Bypassing Good Judgment

**INDOT and Its Over-expansion
of the State Road 45/46 Bypass
through Bloomington**

Presented by
Bloomington Transportation Options for People (B-TOP)
Bloomington, Indiana • info@b-top.org

July 13, 2010

Figure 3. The Bypass at 10th Street. The 10th Street corridor has seen a 25% drop in motor-vehicle traffic and a 300% growth in transit use over the past 15 years. 7% of trips on it are now by transit.

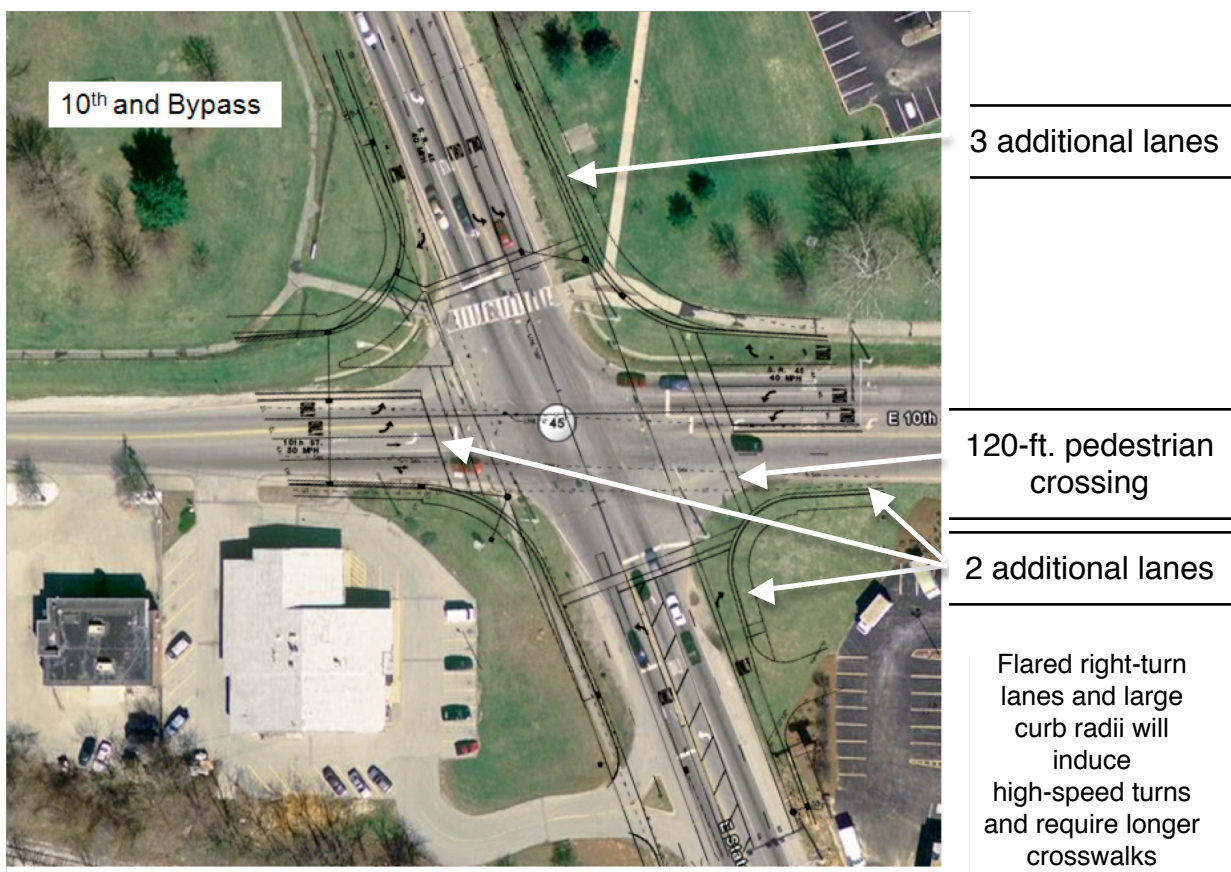
The entire two-lane section is slated to become a divided four-lane road, with left-turning blisters at access points and multiple turn lanes at intersections. The design includes new connectivity to the east of the Bypass at 14th and 7th Streets. There will be double-left turns at virtually every leg of each existing intersection, often with right-turn lanes as well, thus adding two and sometimes three lanes to every leg of these intersections.

The intersections at 10th and 3rd Streets and the new intersection at 7th Street are of significant concern because these are urban corridors, with many bicyclists, walkers, and transit users. Also of great concern are the unnecessary added travel lanes throughout the project length, which will eliminate tree buffers and the tree canopy -- all this to handle traffic volumes the road will never carry.

Figure 4. The Bypass at 3rd Street. A study estimates more than 400 pedestrian crossings a day at this intersection.

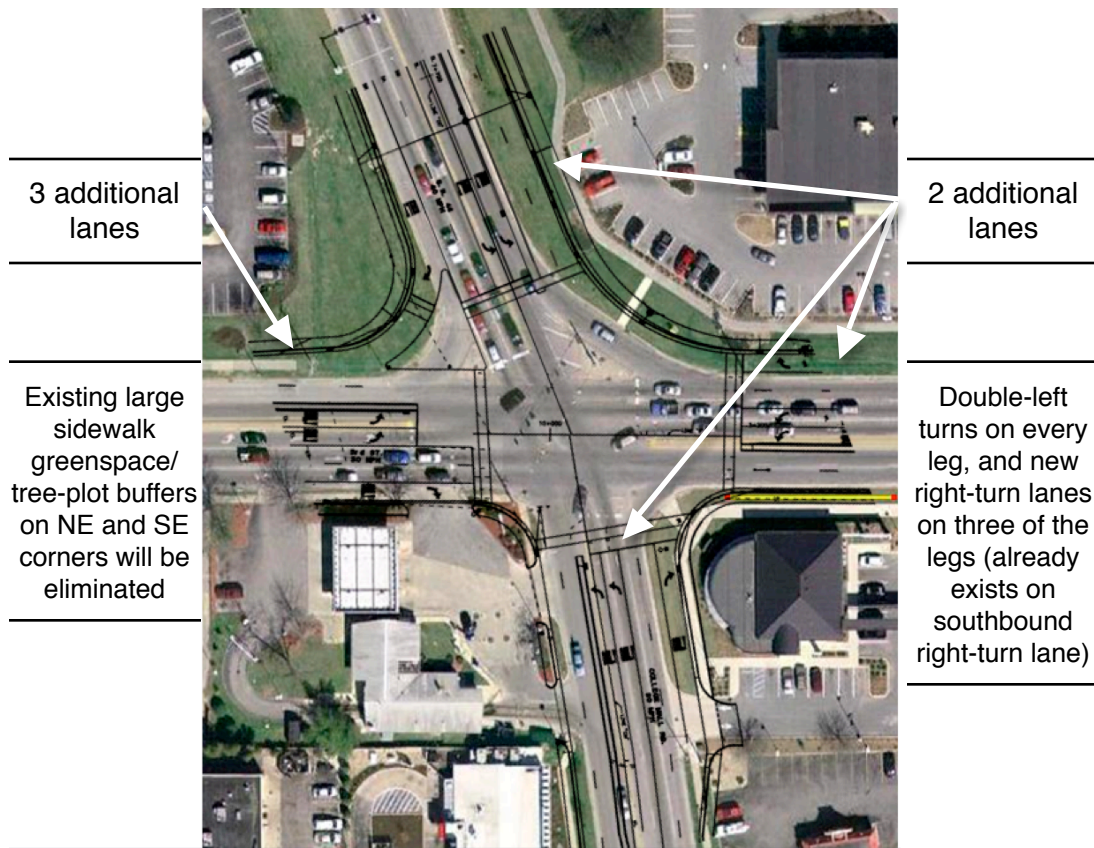
- The northeast corner of 3rd and the Bypass has had massive development in the last 15 years. It used to have just a funeral home; now it has a CVS, Staples, Barnes & Noble, and Best Buy, to name a few. A [pedestrian-crossing study](#) done in 2007 showed more than 400 daily pedestrian crossings at this intersection. Also, the city just finished the [College Mall Pedestrian Accessibility Study](#). This is a very detailed assessment of the area developed to improve the pedestrian environment and encourage pedestrian travel.

Figure 7: Expected vs. actual traffic on the Bypass. INDOT predicted sharp growth that has not materialized.

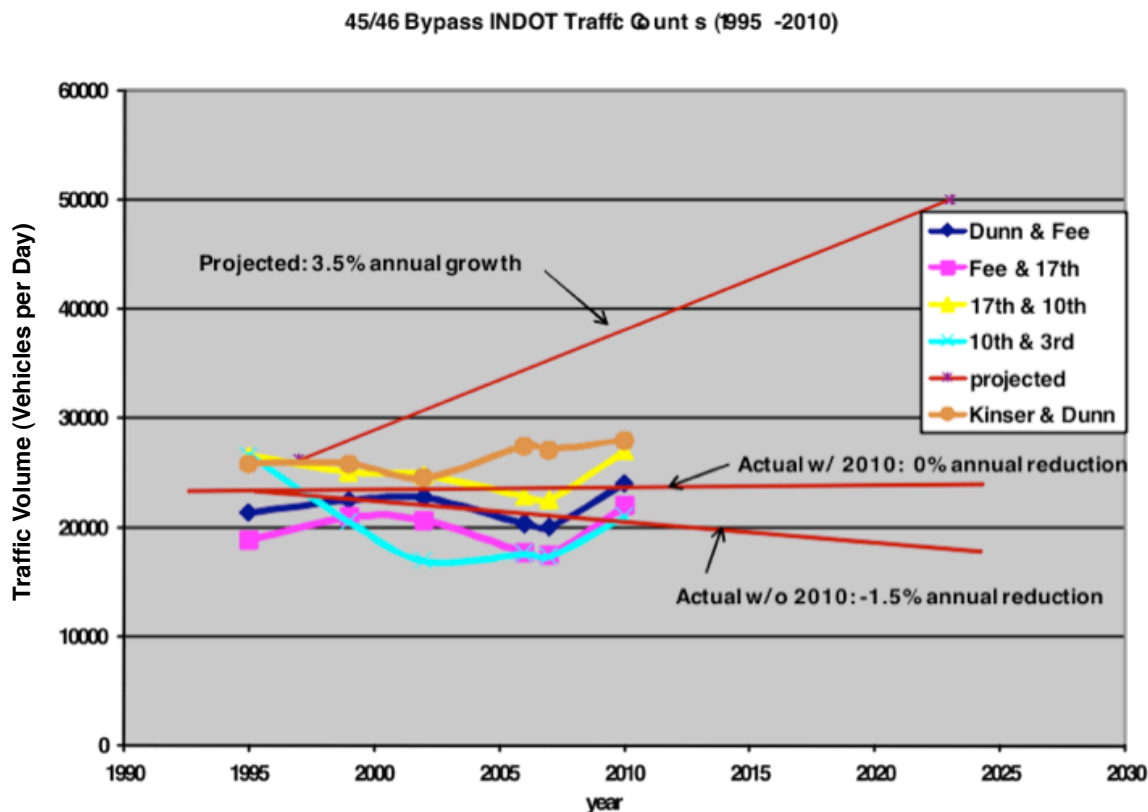
The 1997 traffic was 26,200 VPD, and the 2023 projection is almost twice that, at 50,040 VPD — an expected annual growth rate of 3.5%. (See upper red line on the graph in Figure 7.)

However, this growth did not happen. Since then, the city has purposely directed growth to the west. According to INDOT's published traffic counts, the Bypass traffic actually declined at an average annual rate of -1.5% between 1995 and 2006.¹

The actual counts thus do not come close to INDOT's 1997 projections. Even State Road 37, the largest and busiest road in Bloomington, has never carried more than 40,000 VPD according to INDOT counts. On the basis of its long-ago estimating mistake alone, INDOT should reconsider the design of the Bypass.

Figure 9. Bloomington's Master Thoroughfare Plan. INDOT's design for the Bypass did not take Bloomington's policy into consideration at all.

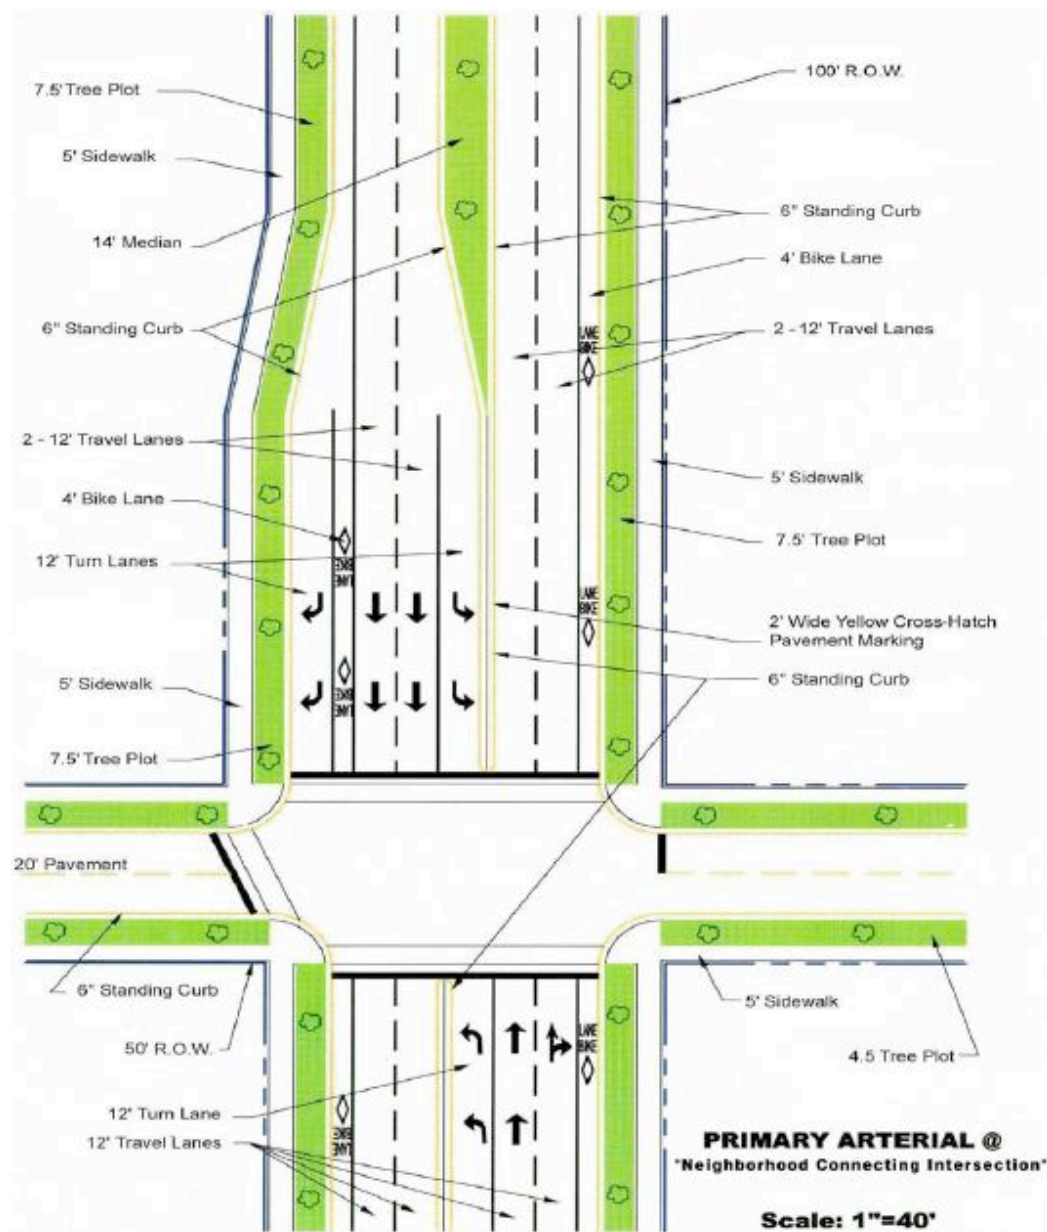
Below is the drawing of the Primary Arterial in Bloomington’s Master Thoroughfare Plan.² This could be described as a “boulevard.” It has bike lanes, tree-plots with trees, and a grassy median with trees. It has 5 or 6 lanes maximum (right turn lane optional), and no double left-turns. These design features create a boulevard sensation and reduce driving speeds, yet handle significant traffic flow.

These features are not reflected in INDOT's design. The design is actually inconsistent with the city's Master Thoroughfare Plan, in contrast to Mr. Tally's statement.
